ADDENDUM NO. 2

Antwerp Square – Phase 1

MWB Investments, LLC

Bockrath & Associates Engineering and Surveying, LLC

Title:
TIMBERFORM METAL BOLLARDS
MODEL NO. 2190-RH
REMOVABLE BOLLARD
WITH HASP/HOLE COVER

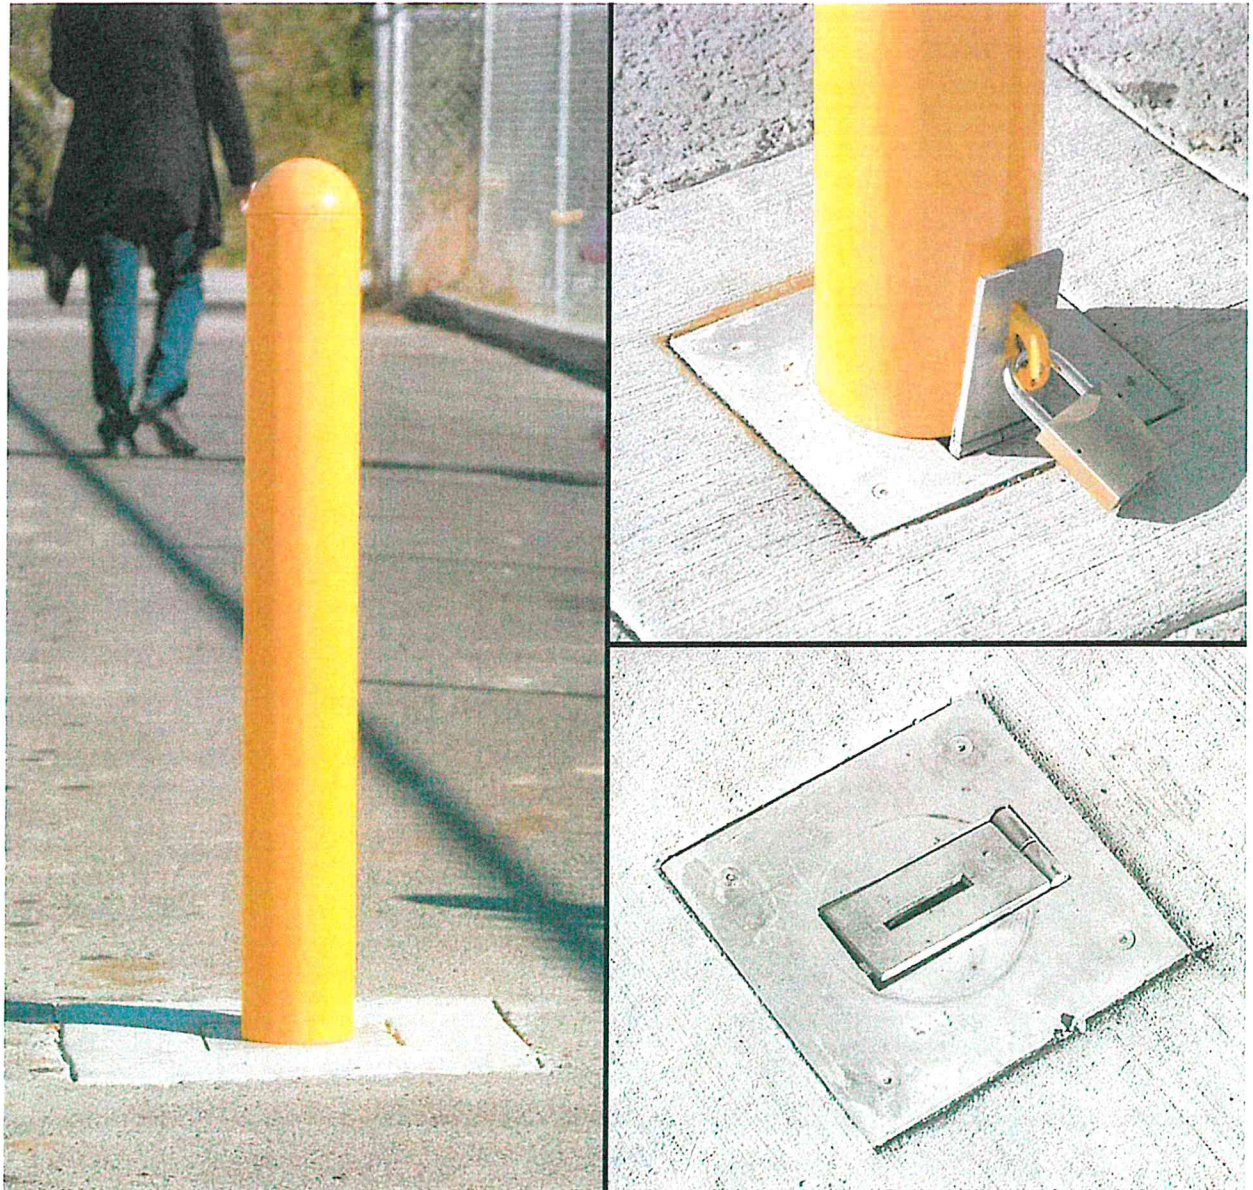
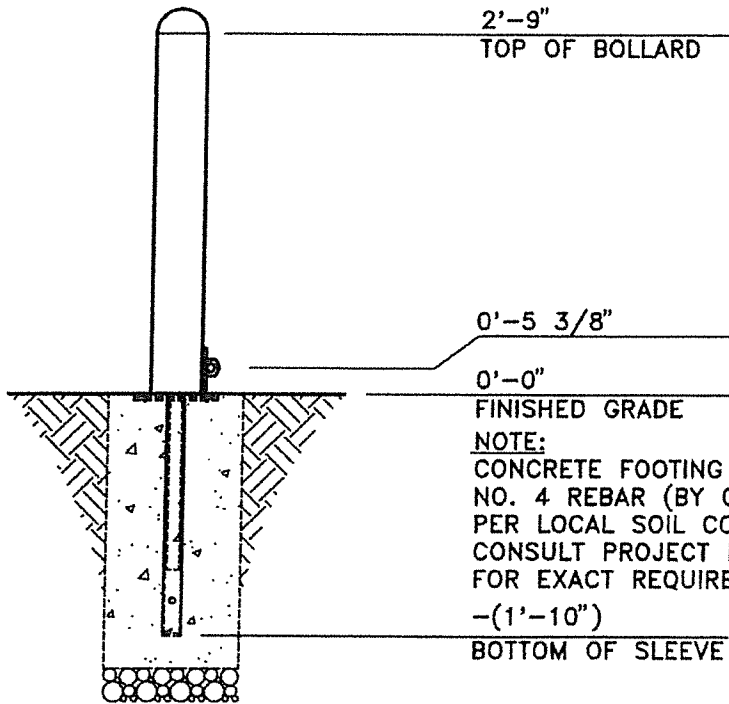
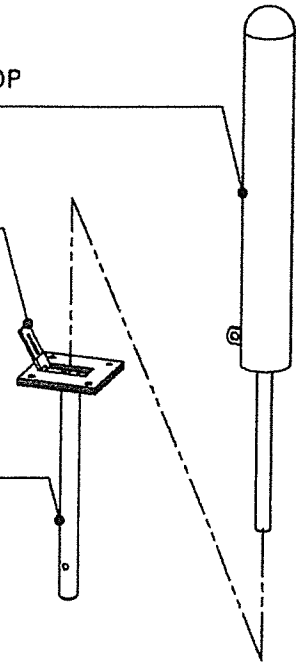
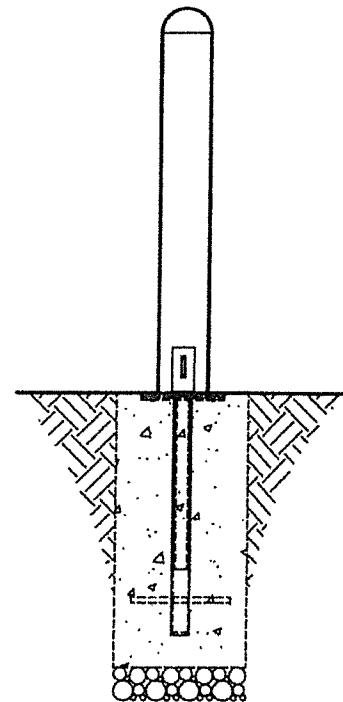
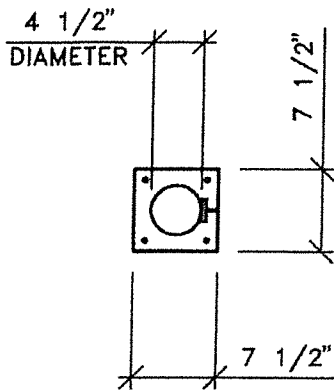
4. What are you using for pipe bollards? The bid form says as per spec, I could not find anything listed.

22. Is there a detail for the removable bollards that I am not seeing?

Answer: See detail in this addendum.

Answer: Bollard detail included in this addendum.

Removable Bollard shall be TimberForm® model No. 2190-RH in yellow color finish as selected by the owner's representative and in the quantity shown on the bill of materials or the project drawings. Manufacturer, Columbia Cascade Company, 1300 SW Sixth Avenue, Suite 310, Portland OR 97201-3464 U.S.A. or Approved Equivalent.
